Access Compliance Report

Public Rights-of-Way

(Curb Ramps)

Intersection ID: 31587	Main Street: TRIBUNE_DR	Cross Street: OASIS_LN	Location: W
ADA ID: 7120D4E20AAC	Ramp Type: PerpDiag	Initial Pass/Fail: Pass	Overall Compliance: No
Codes/Mitigation Info/Possible Solution		Field Measurements/Component Compliance	
Severity Score: 0.25

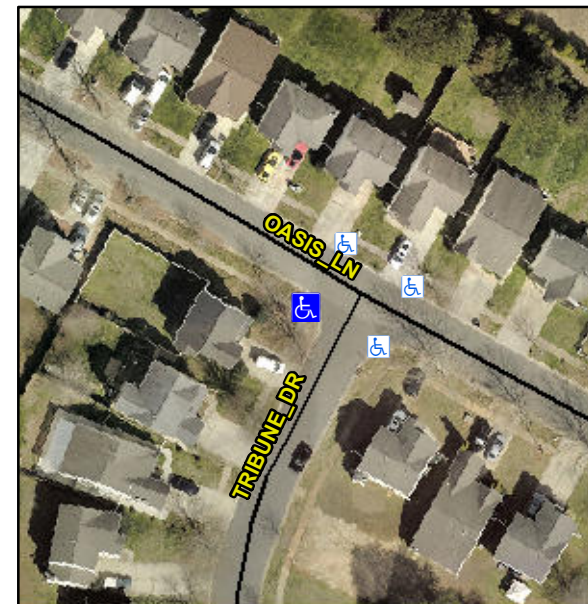
R304.5.3, R304.2.1, R305.2

Compliance	Description	Data	Compliance	Description	Data
N/A	Ramp Length (in)	84.0	Yes	Ramp Slope (%)	5.9
Yes	Ramp Width (in)	48.0	No	Ramp XSlope (%)	4.1
N/A	Flare Type LT	Sloped	N/A	Flare Type RT	N/A
N/A	Flare Slope LT (%)	5.6	Yes	Flare Slope RT (%)	3.0
N/A	Flare Traversable LT?	Yes	N/A	Flare Traversable RT?	Yes
Yes	Landing Length (in)	49.0	Yes	DWS Provided?	Yes
No	Landing Width (in)	47.0	Yes	DWS Contrast?	Yes
Yes	Landing Slope (%)	1.9	Yes	DWS Length (in)	24.0
No	Landing X Slope (%)	6.3	Yes	DWS Full Width?	Yes
N/A	Landing Curb? (Y/N)	No	No	DWS Offset (in)	3.0
N/A	Shared Landing?	No			
Yes	Gutter Ponding?	No	Yes	Gutter Slope (%)	0.0
Yes	Gutter Lip Ht (in)	0.0	No	Gutter X Slope (%)	3.9
N/A	Painted X Walk1?	No	N/A	Painted X Walk2?	No
	X Walk 1 Direction	To SE		X Walk 2 Direction	To NE
N/A	X Walk 1 Width (in)	N/A	N/A	X Walk 2 Width (in)	N/A
	X Walk 1 Slope (%)	2.7		X Walk 2 Slope (%)	1.6
	X Walk 1 X Slope (%)	2.2		X Walk 2 X Slope (%)	1.4

Remove & Replace Curb Ramp With Two New Directional Ramps or Equivalent. Remove & Replace Gutter.
